802.1AX -- Link Aggregation:

Editor's Report: January 2019

802.1AX status

If choose to change Actor_System

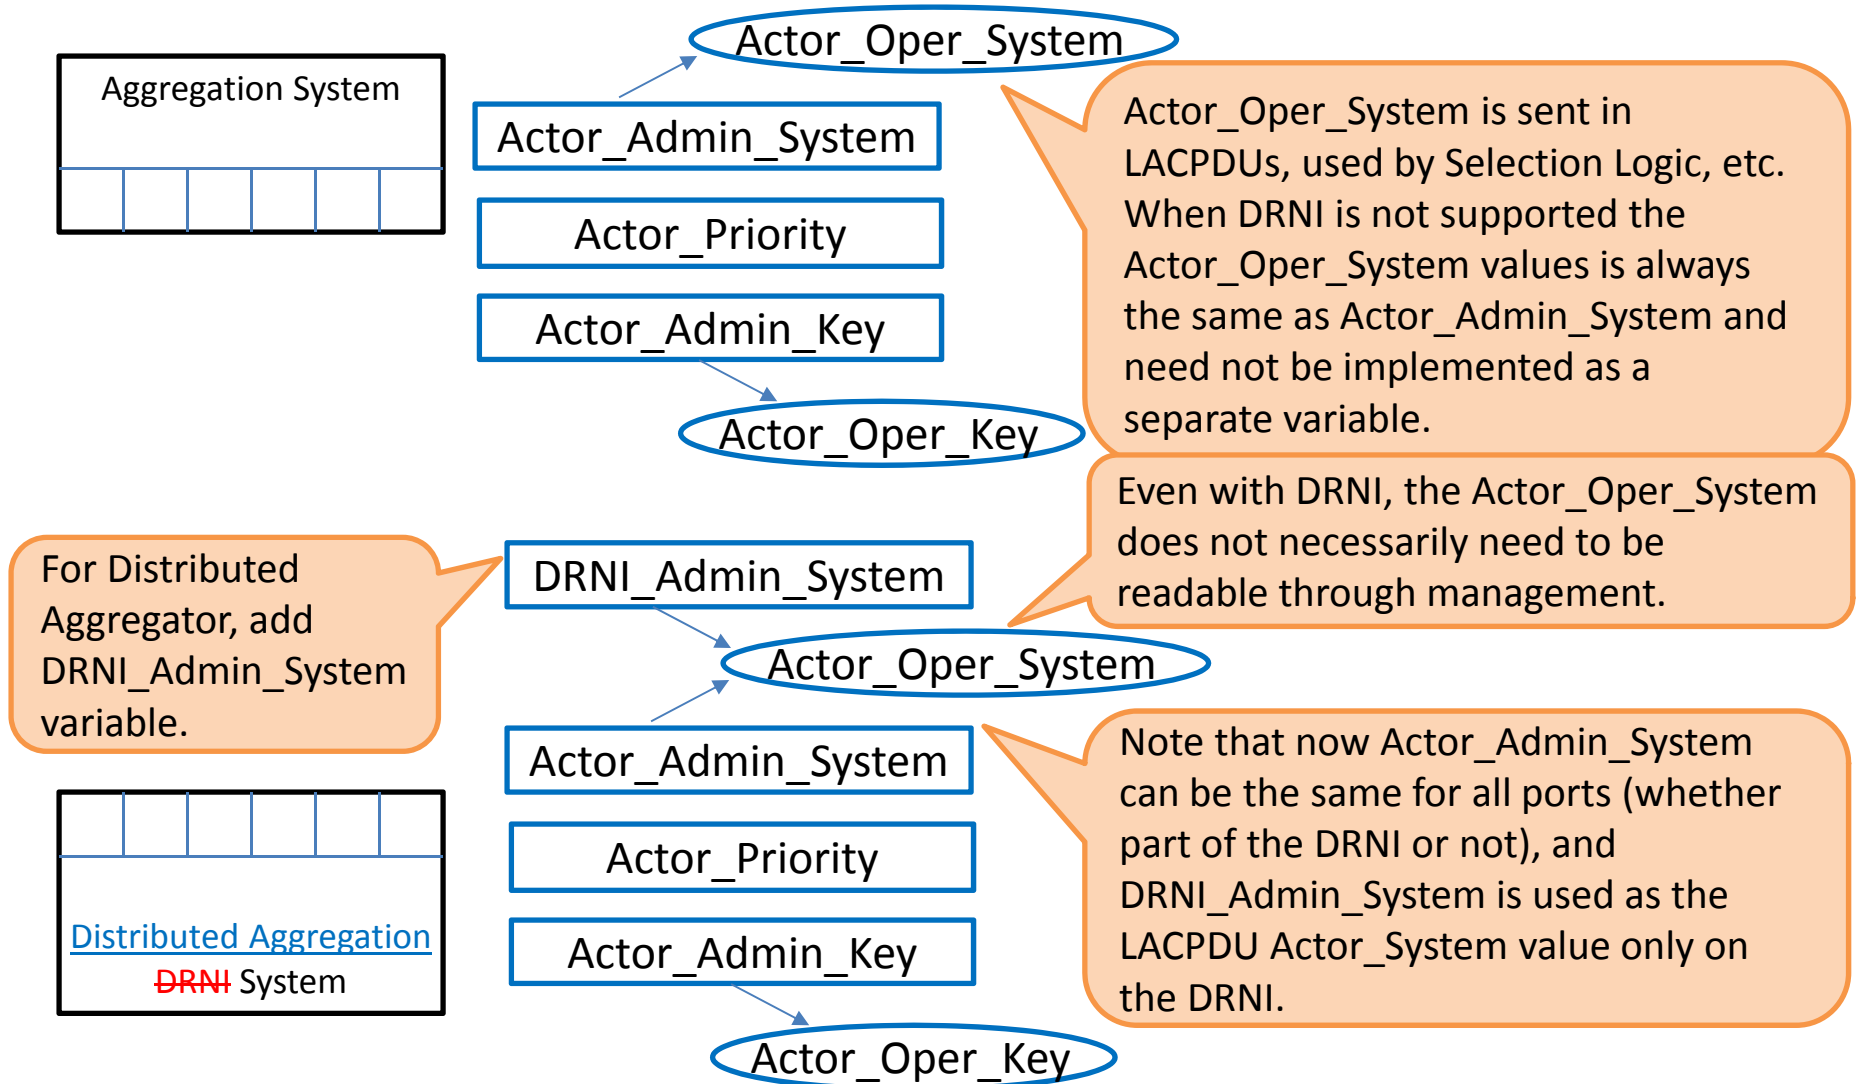
- Mick's comment #82 (in the comment, but not the suggested remedy) seems to suggest changing the LACPDU Actor_System value, rather than the Actor_Key value, when gain or lose communication over the IRC.
- We originally chose to change Actor_Key because:
 1. Didn't want to change the "address" portion of the system identifier when an IRC or DRNI System failed.
 - This was arguably misguided because it confuses the Actor_System function as an identifier with using it as an address.
 2. Already have the Actor_Admin_Key and Actor_Oper_Key variables that allow dynamically changing the key value.
 - If really prefer to change the Actor_System then can rename the current Actor_System to Actor_Admin_System and add Actor_Oper_System. When DRNI is not supported the Actor_Oper_System would always have the same value as Actor_Admin_System and thus need not be implemented as a separate object.

Part of Mick's comment is that we could specify that when the DRNI is formed, the Actor_Oper_System always becomes the highest {Actor_Priority:Actor_Admin_System} value of the paired systems. Then don't need DRNI_Admin_System object at all. Consequence is that we lose the configuration checking provided by verifying that both systems have the same DRNI_Admin_System. Will form a DRNI when any two DRNI Systems get connected via their IRPs. If really want this then should also set Actor_Oper_Key to Actor_Admin_Key of highest priority system.
